ADDENDUM No. 03
DNR-220039
Delaware State Park Wastewater Treatment
April 2, 2024

2. The following additional questions have been received to date:

SECTION D-44
43

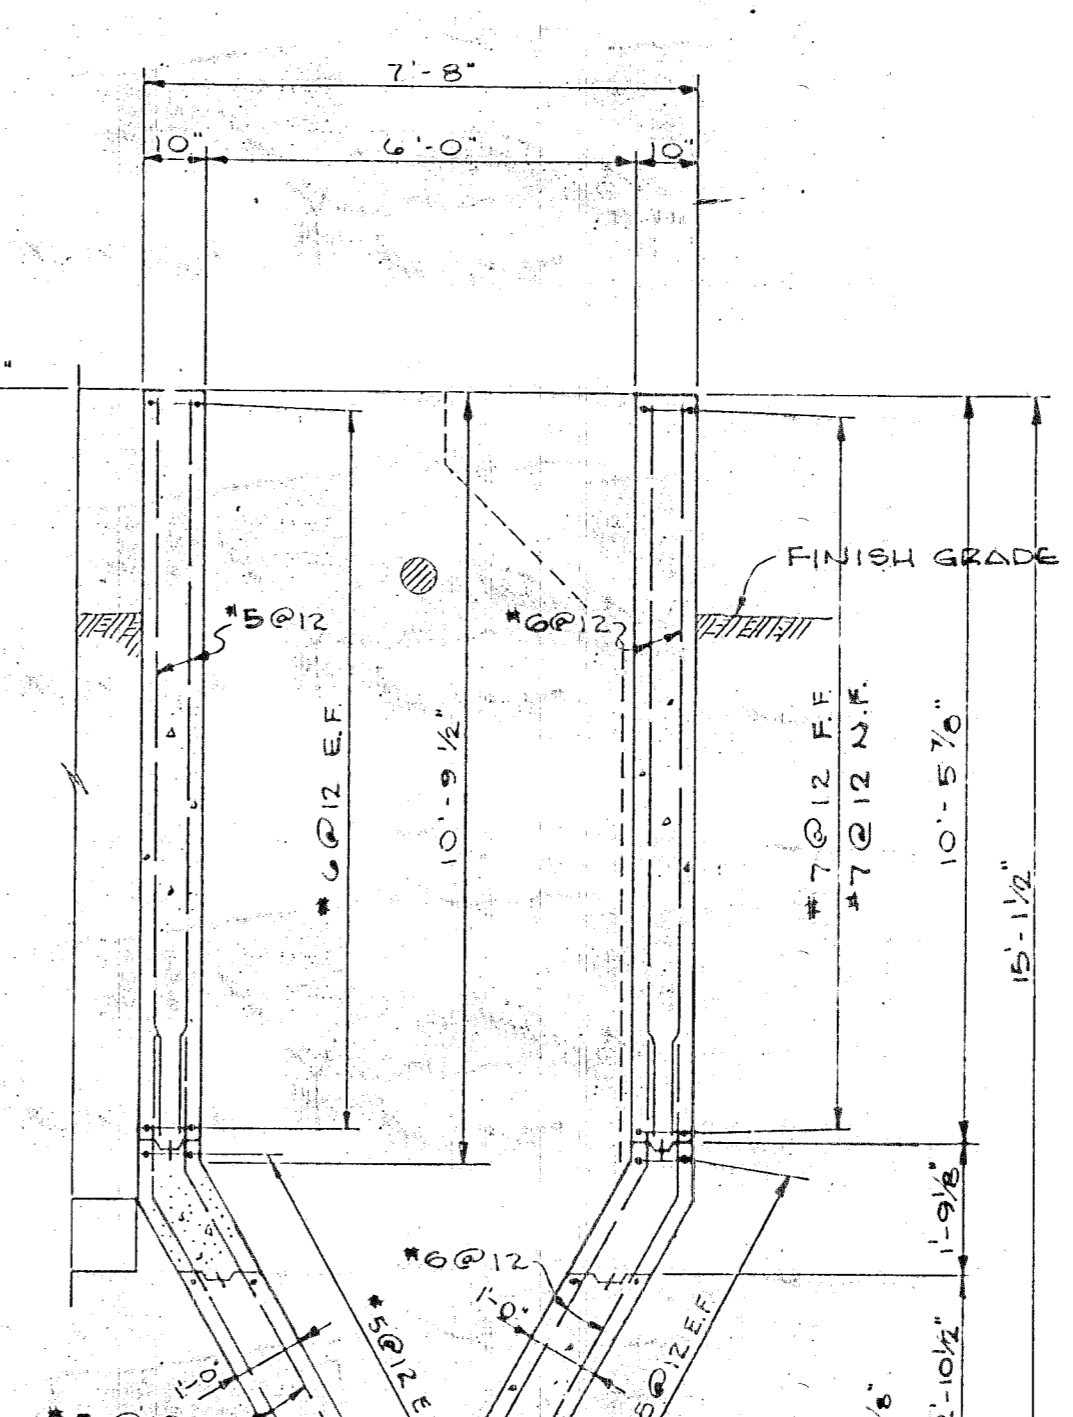
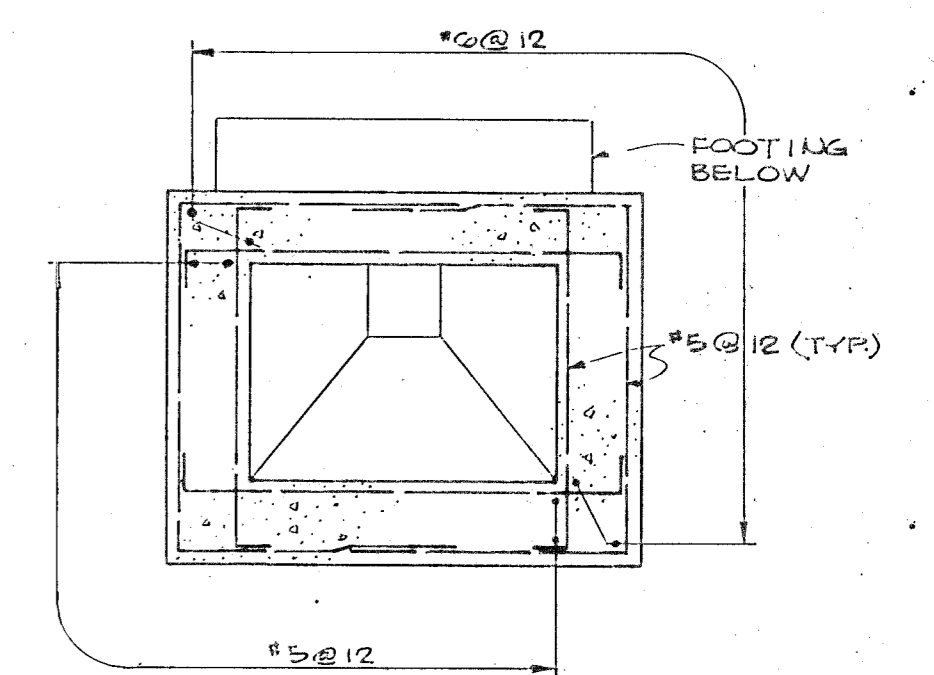
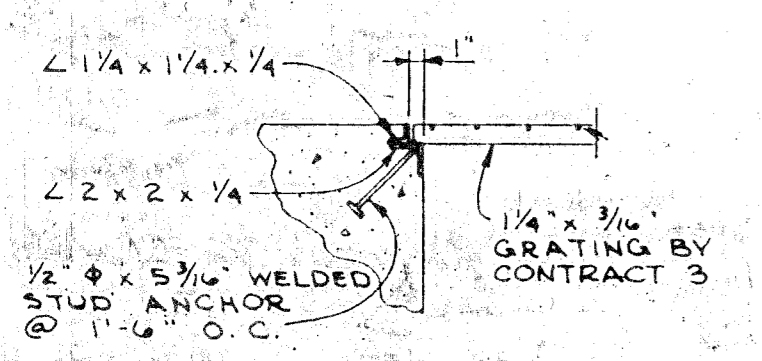
Q: Do you have the plans for the existing Plant so we can see depths and dimensions?

A: *Yes, existing plant plans that pertain are attached. Existing plant depths from top of wall to bottom of concrete (based on plans provided by ODNR); influent box (headworks) – approximately at grade; aeration tanks - approximately 12.5'; settling tank (clarifier) slopes to approximately 16.5'; chlorine contact tank – approximately 12'. The existing WWTP top of wall is approximately 2' to 3' above ground. (attached plans do not necessarily reflect as-built conditions)*
